**Committee of Experts on the Transport of Dangerous Goods
and on the Globally Harmonized System of Classification
and Labelling of Chemicals**

**Miscellaneous proposals for amendments to the
Model Regulations on the Transport of Dangerous
Goods: packagings**

Multiwall Water Resistant Paper Bags (5M2)

Transmitted by the Observer from Turkey

Figure 1 (a)

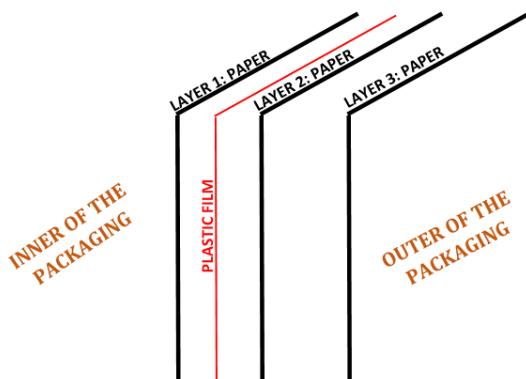
- Turkey requests interpretation of ‘water resistance’ via answers to examples below. Following figures represent ply structures of different paper bags. Which figures can be regarded as water resistant according to the first sentence of 6.1.4.18.2 so that classified under 5M2?
